# College Station LE- ADA Evaluation

**LE-College Station TX, ADA Evaluation**  
**12815 Farm to Market Rd 2154 Suite 160**  
**College Station, TX 77845**  
**Accessibility Evaluation**  
**Inspection Date: 12/28/2022**  
**Inspectors: Christopher Meza**

Report Date: 01/12/2024

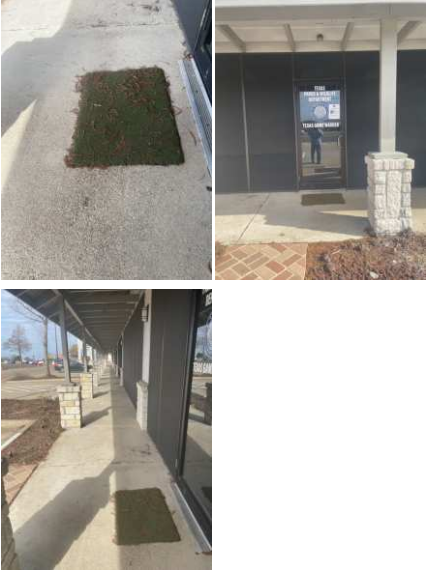
Finding Number	Area Description	Finding	As Built	Recommendation	Citation	Photos	Figure
1	Exterior of Property (Public) : Parking Lot (1 Space) 1 Van - Van Accessible Stall (R)	The van stall is missing a sign identifying it as a van accessible stall. Parking space identification signs shall include the International Symbol of Accessibility. Signs identifying van parking spaces shall contain the designation "van accessible."	N/A	<a href="https://www.access-board.gov/ada/#ada-502_6">https://www.access-board.gov/ada/#ada-502_6</a>	2012 TAS Section: 502.6 2010 ADAS Section: 502.6		
2	Exterior of Property (Public) : Parking Lot (1 Space) 1 Van - Van Accessible Stall (R)	The stripe is missing at the right side of the right parking stall which identifies its border. Vehicle spaces shall be marked to define the width, and shall have an adjacent access aisle.	Missing striping on right side. Accessible stall border is a curb-recommend painting the ground next to the curb. The width of the space can be taken all the way up to the curb. Low priority when compliant width of stall is provided	<a href="https://www.access-board.gov/ada/#ada-502_2">https://www.access-board.gov/ada/#ada-502_2</a>	2012 TAS Section: 502.2 2010 ADAS Section: 502.2

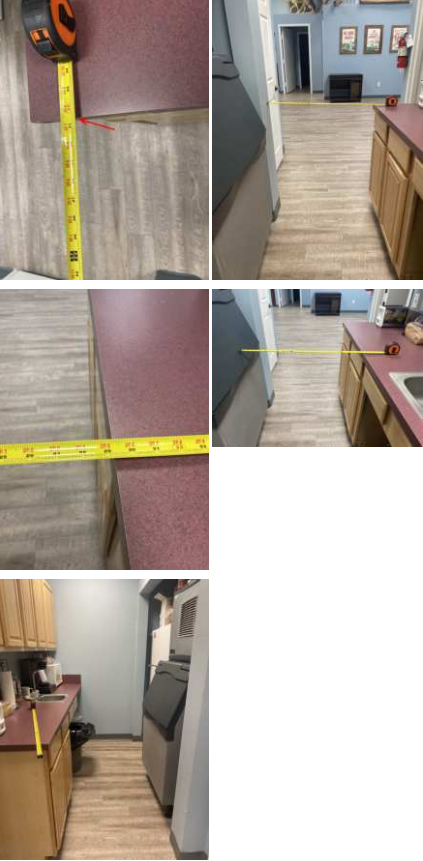
Finding Number	Area Description	Finding	As Built	Recommendation	Citation	Photos	Figure
10	First Floor Main Building (STAFF): Conference Room	The element projects more than 4 inches into the circulation path. Wall-mounted objects that have leading edges between 27 inches and 80 inches from the floor must not project more than 4 inches into the circulation path. Protruding objects that extend to the floor or within 27 inches of the floor are cane detectable and are therefore not hazardous. Where it is necessary or desirable to have objects protrude from the wall, a manner of cane detection must be provided.	Mounted phone measures at 5". There is enough accessible space to maneuver around object.	<a href="https://www.access-board.gov/ada/#ada-307_2">https://www.access-board.gov/ada/#ada-307_2</a>	2012 TAS Section: 307.2  2010 ADAS Section: 307.2		
11	First Floor Main Building (STAFF): Conference Room	The light switch is not accessible because it requires tight grasping, pinching or twisting of the wrist. Controls and operating mechanisms shall be operable with one hand and shall not require tight grasping, pinching or twisting of the wrist. The force required to activate controls shall be no greater than 5 pounds of force.	N/A	<a href="https://www.access-board.gov/ada/#ada-309_4">https://www.access-board.gov/ada/#ada-309_4</a>	2012 TAS Section: 309.4  2010 ADAS Section: 309.4

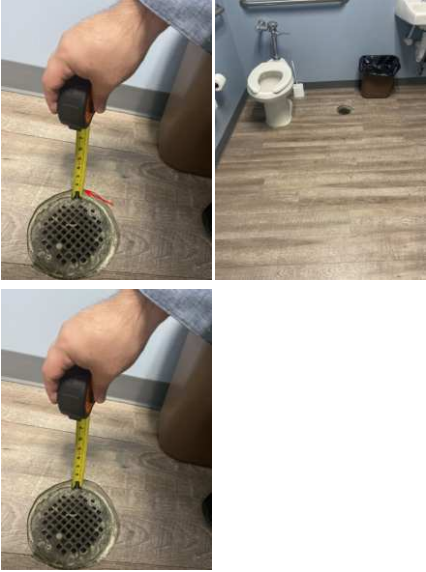
Finding Number	Area Description	Finding	As Built	Recommendation	Citation	Photos	Figure
14	First Floor Main Building (STAFF): Conference Room	The element projects more than 4 inches into the circulation path. Wall-mounted objects that have leading edges between 27 inches and 80 inches from the floor must not project more than 4 inches into the circulation path. Protruding objects that extend to the floor or within 27 inches of the floor are cane detectable and are therefore not hazardous. Where it is necessary or desirable to have objects protrude from the wall, a manner of cane detection must be provided.	AED sign protrudes over 8" into walkway.	<a href="https://www.access-board.gov/ada/#ada-307_2">https://www.access-board.gov/ada/#ada-307_2</a>	2012 TAS Section: 307.2  2010 ADAS Section: 307.2

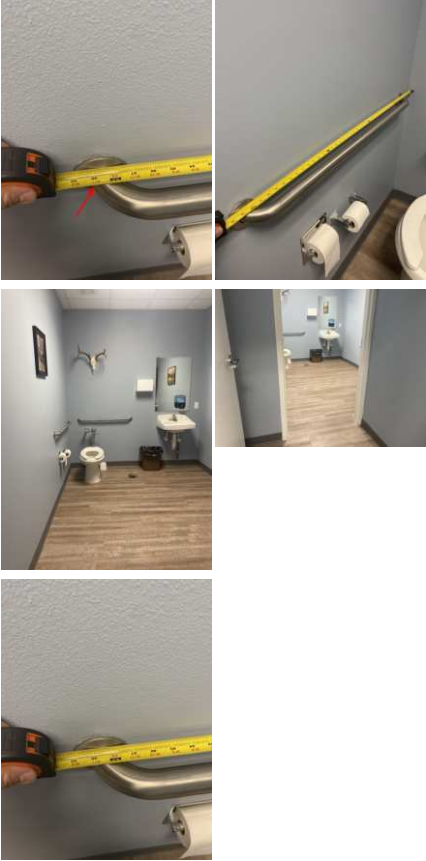
Finding Number	Area Description	Finding	As Built	Recommendation	Citation	Photos	Figure
15	First Floor Main Building (STAFF): Kitchenette	The route of travel does not provide a minimum width of 36 inches. The clear width shall be permitted to be reduced to 32 inches minimum for a length of 24 inches maximum provided that reduced width segments are separated by segments that are 48 inches long minimum and 36 inches wide minimum.	Width measures no more than 32" and extends longer than 24".	<a href="https://www.access-board.gov/ada/#ada-403_5_1">https://www.access-board.gov/ada/#ada-403_5_1</a>	2012 TAS Section: 403.5.1  2010 ADAS Section: 403.5.1
